RE: McClenny Acres Mitigation Site – Baseline Monitoring Document and As-Built Baseline Report  
DEQ Contract Number 007423, RFP# 16-007279, DMS# 100038  
Neuse River Basin 03020201; Wayne County, NC

**BASELINE MONITORING  
DOCUMENT AND AS-BUILT  
BASELINE REPORT  
FINAL**

**McClenny Acres Mitigation Site**

We have reviewed the comments on the As-Built Baseline Report for the above referenced project dated May 4, 2021 and have revised the report based on these comments. The revised documents are submitted with this letter. Below are responses to each of your comments. For your convenience, the comments are reprinted with our response in italics.

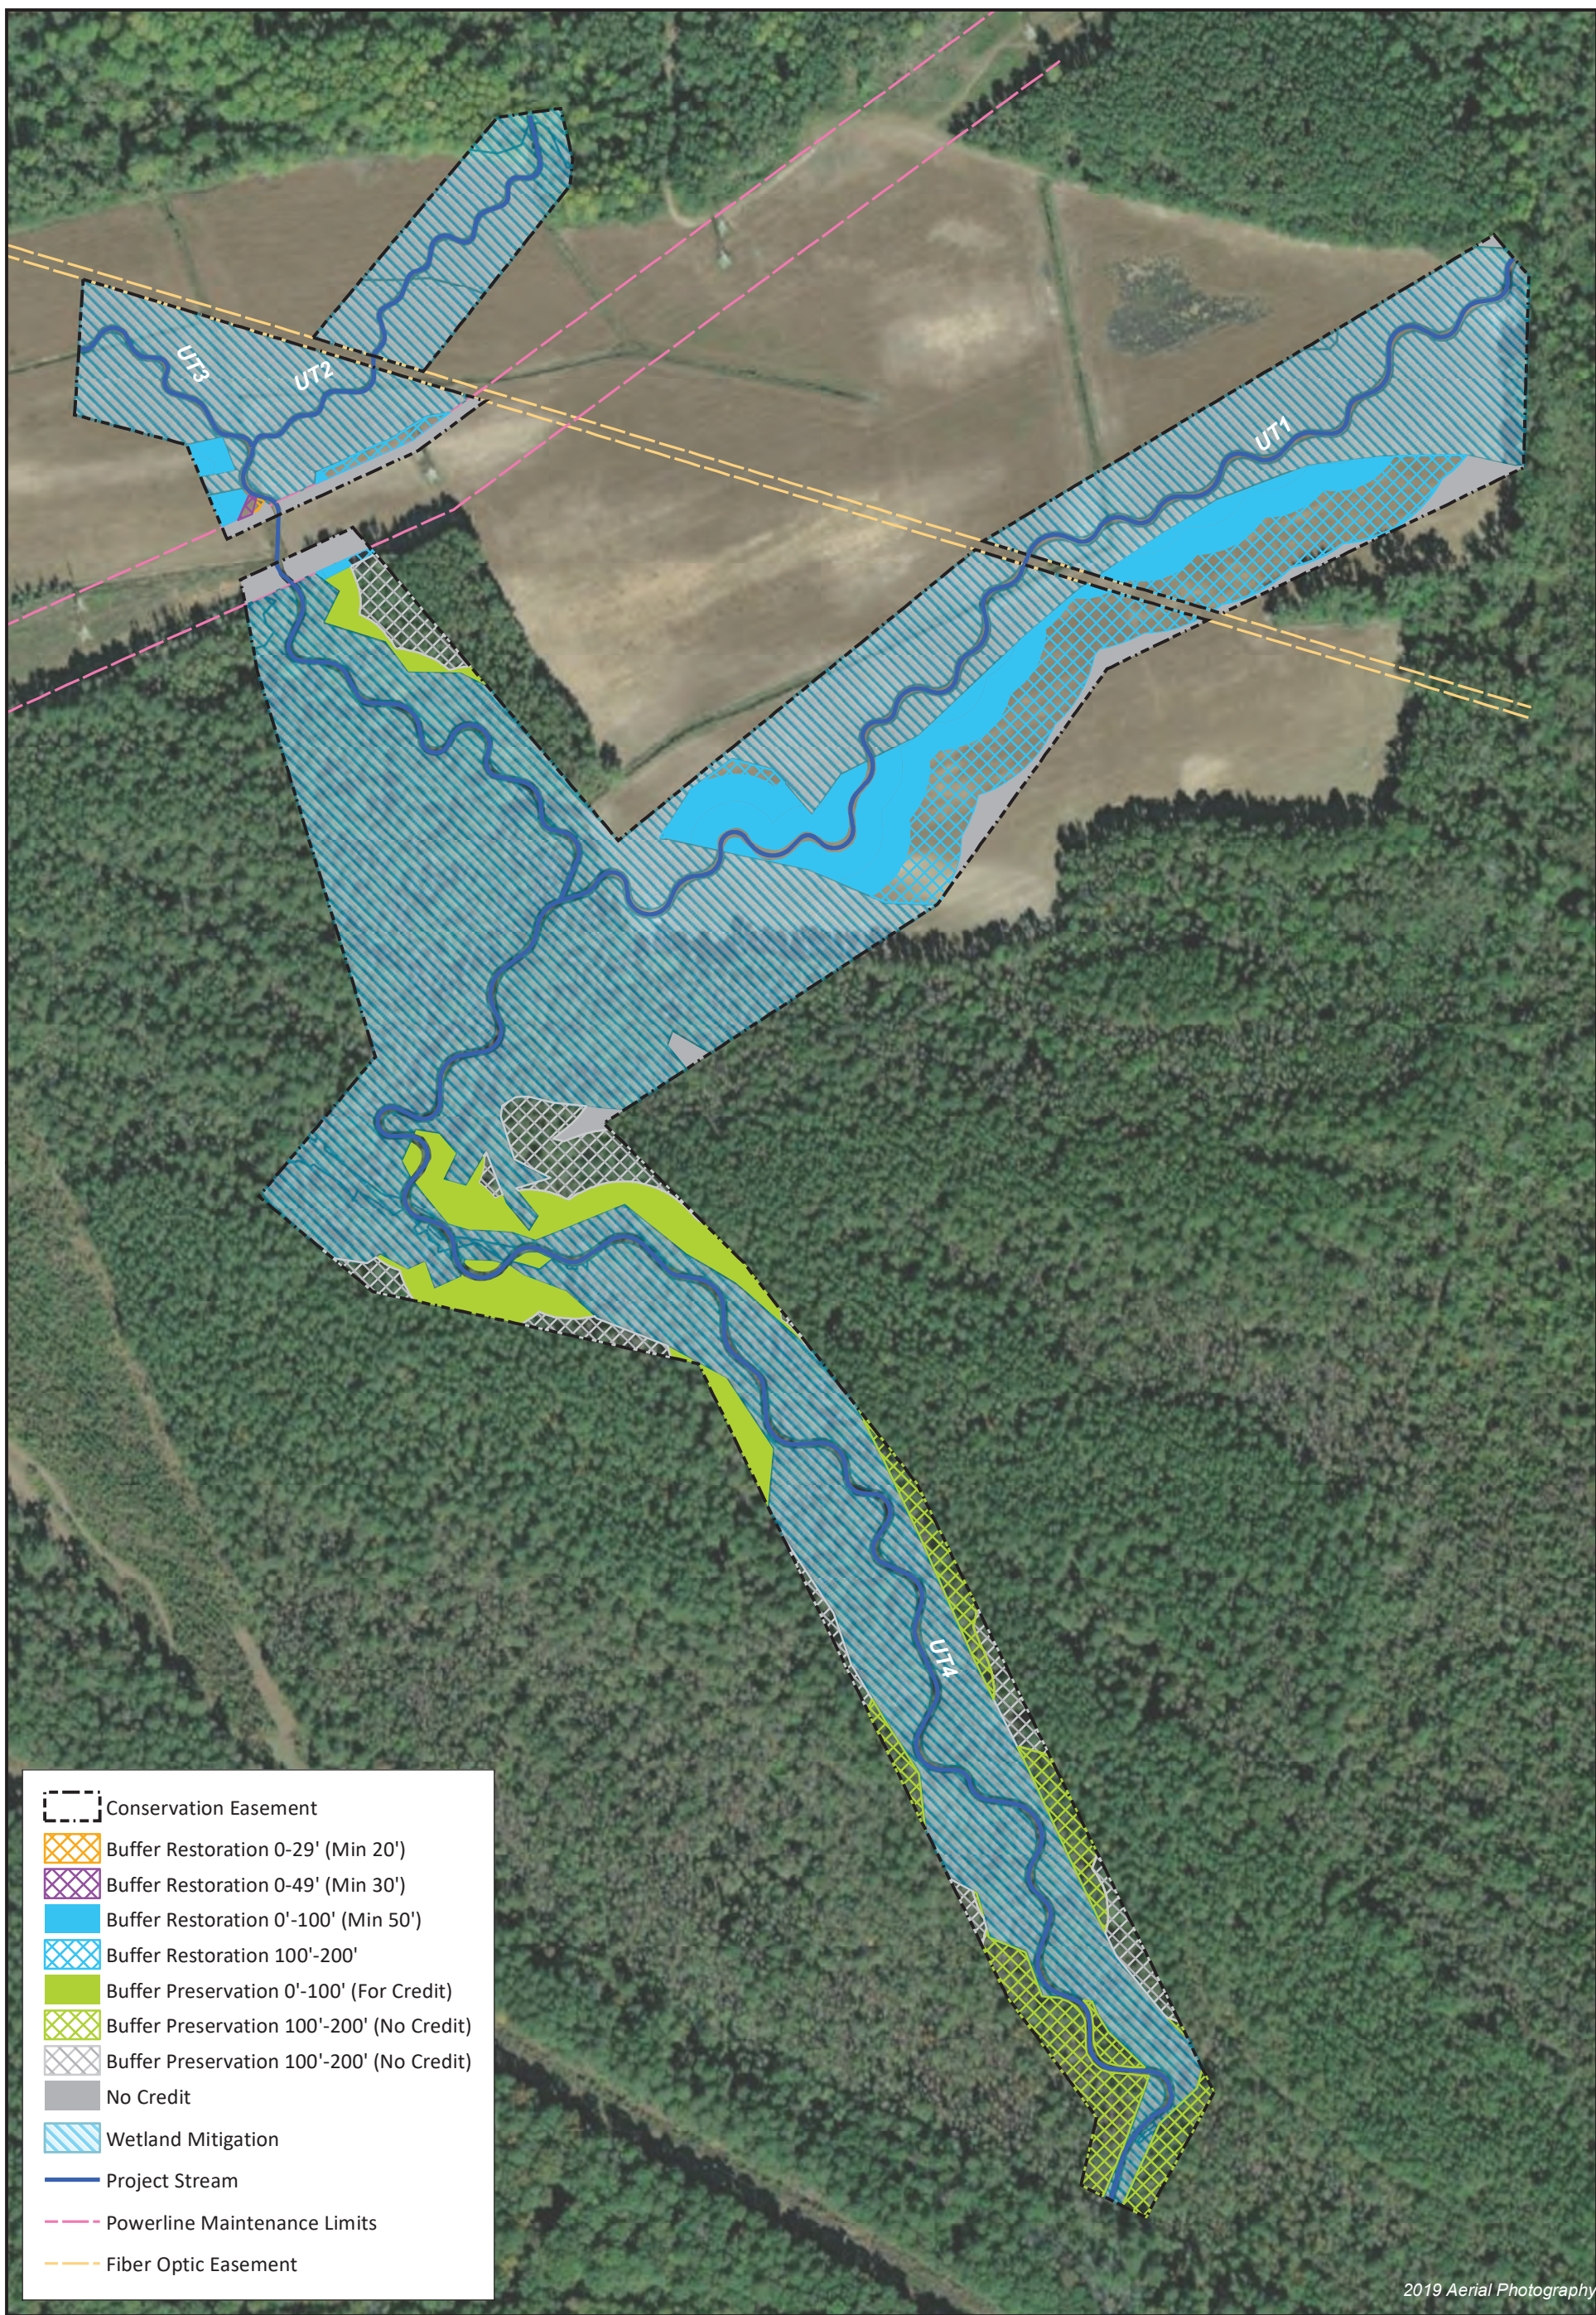
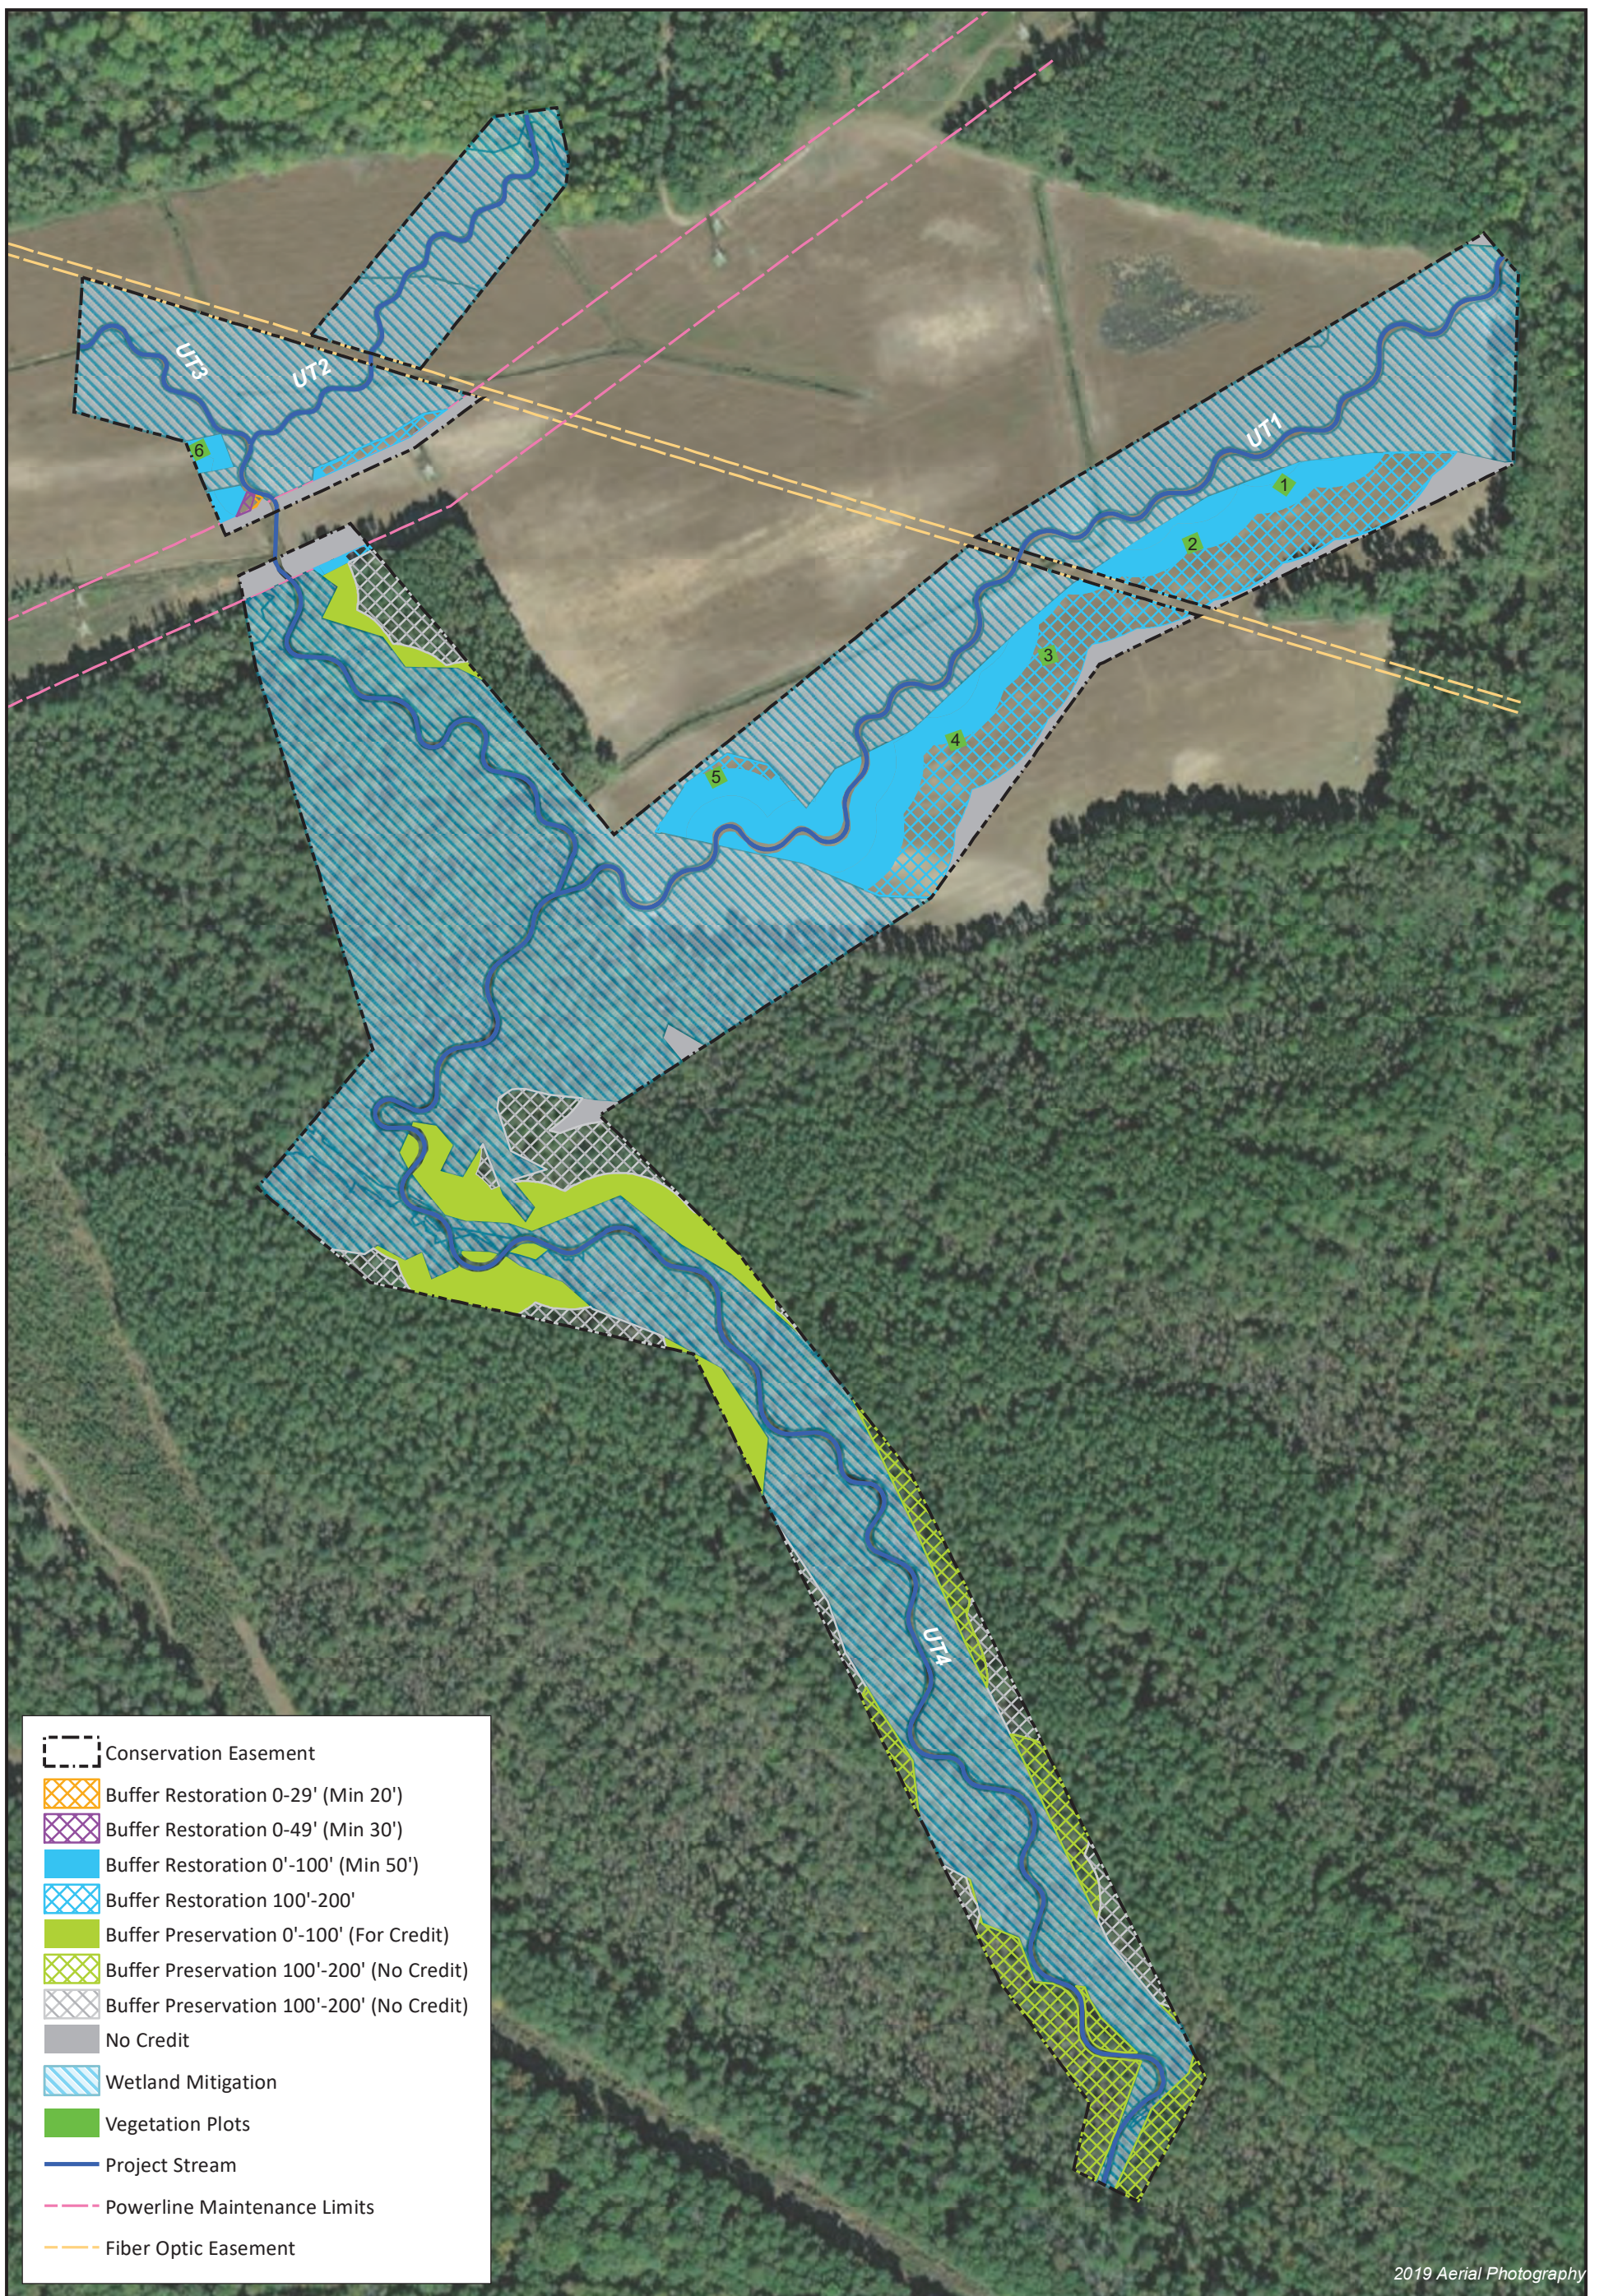
- b. Figure 4: Recommend removing “Buffer Restoration 0-49’ (Min 30’)” item from the map and lumping in with the 50’-100’ (change name to 0’-100’) category so it matches the buffer width categories on Table 2.

c. Table 2: Please verify the second row of the table (57,622 ft<sup>2</sup> on UT1 and UT3) is not viable for conversion to nutrient offset.

*Zones with a riparian buffer from 0’-100’ and a minimum width of 50’ have been combined into a single category on Figure 4 (Appendix 1), Table 2 (Appendix 1), and the As-Built Survey (Appendix 3). We feel it is necessary to include the 0’-49’ (Min. 30’) category to account for the area along UT3 that is viable for 100% buffer restoration credit but not viable for conversion to nitrogen nutrient offset credit while attempting to preserve format of NCDWR template version Buffer\_Mitigation\_Tables\_1.0\_2018\_12\_20. This template was the tool in use during the buffer*

*Much of this area is viable for conversion to nitrogen nutrient offset credit. Figure 4 and Table 2 have been corrected to include appropriate buffer and nutrient offset zones.*
